**National Grid Company plc**  
Grid Code Review Panel

**Review of Electricity Market Information**  
Proposed changes to Grid Code Operating Codes OC1 and OC2

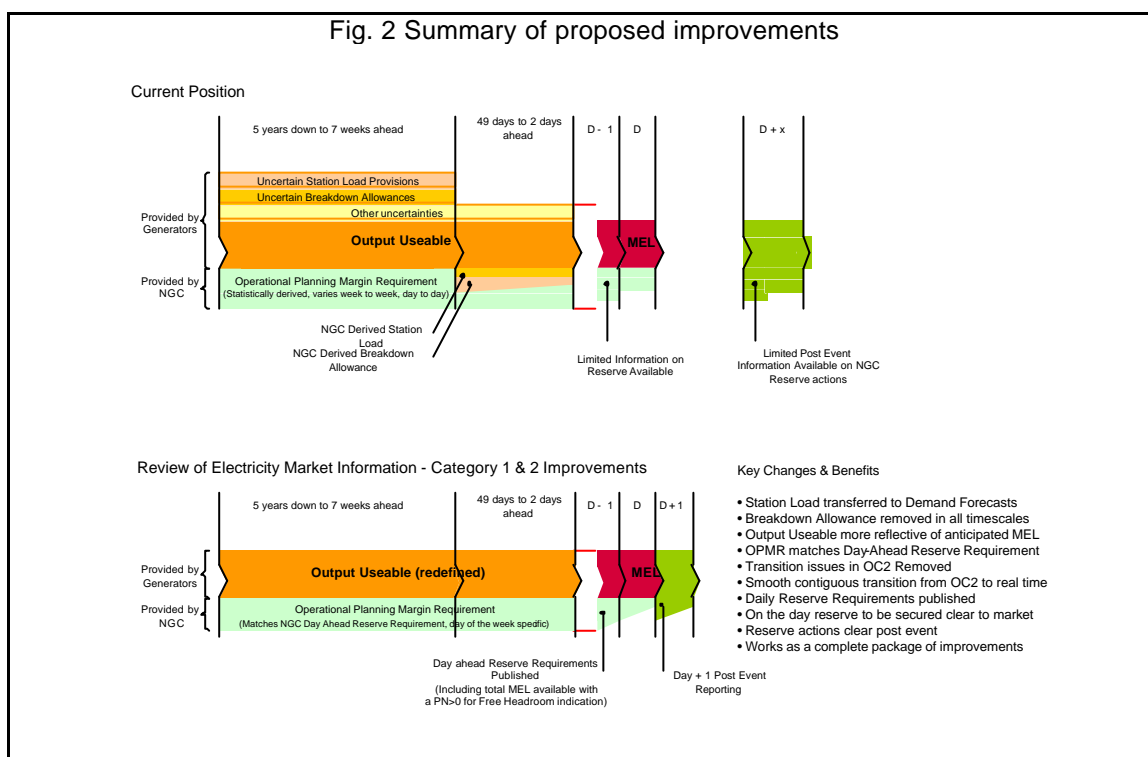
- The market information may be incomplete;
  - It may be inconsistent;
  - It may lack clarity;
  - Market participants may not understand it.
- 2.2 The issues outlined above may cause uncertainty in the market information received and disseminated by NGC. An example of inconsistent information is shown in Figure 1. NGC receives the Output Usable (OU) data from Generators across various timescales, ranging from 3-5 years ahead of real time to 2-14 days ahead of real time. The current OC2 provisions do not allow Generators to provide estimates of OU in a consistent manner across all timescales; for certain timescales (from 5 years to 7 weeks ahead of real time), Generators are required to adjust OU estimates for breakdown and station load but for other timescales, they are required to submit OU estimates without such allowances (NGC estimates these allowances for the period 2-49 days ahead of real time). This inconsistent treatment of OU adds unnecessary complexity for Generators in their OU submissions. From NGC's perspective, there is uncertainty regarding the level of allowances made by individual Generators, which feeds into any OU-based information that NGC disseminates to the market.

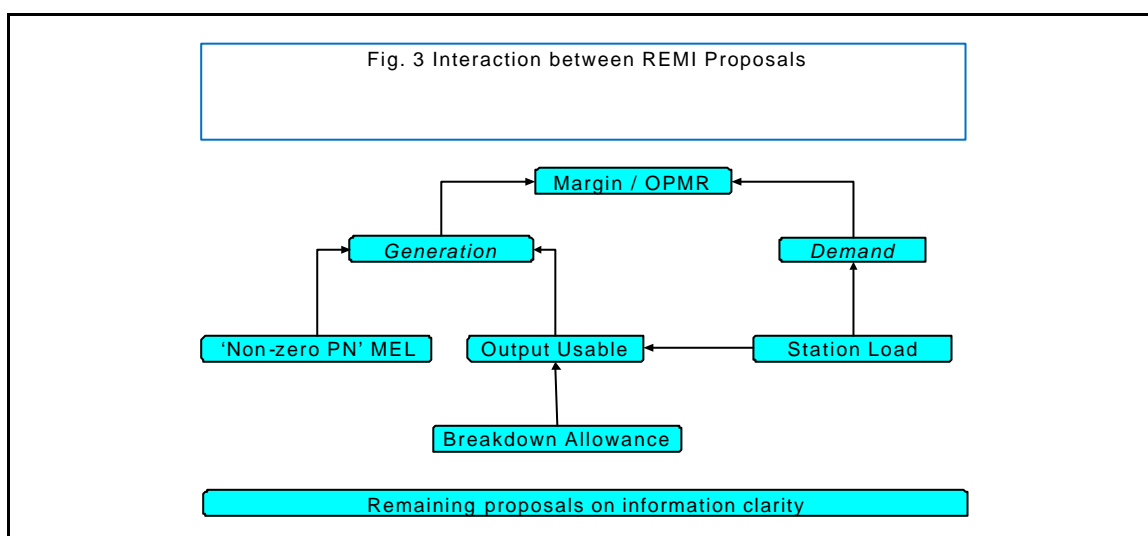
- Margin requirements
- 3.4 REMI has looked at each of the above areas and developed a package of proposed improvements. Figure 2 shows both the current processes surrounding information received and disseminated by NGC, and the proposed improvement package. The processes span timescales ranging from 5 years ahead of day to after-the-day events.

- 3.5 The existing processes have a number of weaknesses which are highlighted in the top half of Figure 2:
- 3.5.1 The OU data received by NGC is not consistent across all timescales because some timescales (5 years down to 7 weeks ahead) include allowances for breakdown and station demand whilst others (49 days down to 2 days ahead) do not (NGC has to estimate these allowances for the shorter timescales). This historical anomaly causes uncertainty in the level of OU which feeds into OU-based and margin requirement information provided to the market.

- 3.5.2 The current methodology for determination of Operational Planning Margin Requirement (OPMR) is based on a statistical approach which is non-transparent and difficult to explain concisely.

- 3.5.3 OPMR is not specific to the day of the week and hence can not easily be translated into a day ahead Reserve Requirement (the day ahead Reserve Requirement is typically different for Monday-Thursday, Saturday and Sunday).

- 3.5.4 Limited information is published on availability of reserve (day ahead) and on NGC's reserve actions (post event).
- 3.5.5 The published MEL (Maximum Export Level) includes data corresponding to '0 PN' machines (i.e. where generation is not readily available and warming may be required) which does not give a true indication of the generation available.

- 3.6 The net effect of the above weaknesses is that the D-1 data (MEL and Reserve) is not aligned with that corresponding to longer timescales (OU and OPMR). One consequence of the disparity between two sets of data is the uncertainty in the determination of 'surplus' (= generation – (demand + OPMR)); this uncertainty means that it is not clear in advance to the market that the margins are sufficiently low that a NISM (Notice of Insufficient System Margin) is likely to be issued by NGC.

- 3.7 The bottom half of Figure 2 summarises the proposed improvements which include:
- ✓ Removal of breakdown allowance from OU submissions across all timescales;

- ✓ Removal of station demand from OU submissions across all timescales;
  - ✓ Addition of station demand to demand forecasts by NGC;
  - ✓ Revised calculation methodology for OPMR which matches Day Ahead Reserve Requirement;

- ✓ Publication of day ahead reserve requirements;
  - ✓ Publication of a 'MEL-type' figure which excludes '0 PN' data and gives a better indication of headroom that is readily available.

- ✓ Publication of post event information on NGC's reserve actions on D+1.
- 3.8 The above improvements consist of several individual proposals which are interdependent. Because of the linkages between these proposals, selective implementation would not achieve the maximum benefit, and would increase the complexity and explanations required for each proposal. The proposals should therefore be seen as an integrated improvement package, as shown in Figure 3. On the generation side, the breakdown allowance has an impact on the definition of Output Usable which in turn affects the overall margin. The removal of '0-PN' data provides more useful information on generation that is readily available. The allowance for station load, which currently affects generation availability via Output Usable, is to be added to the demand forecasts. Details of individual proposals are covered in section 4.
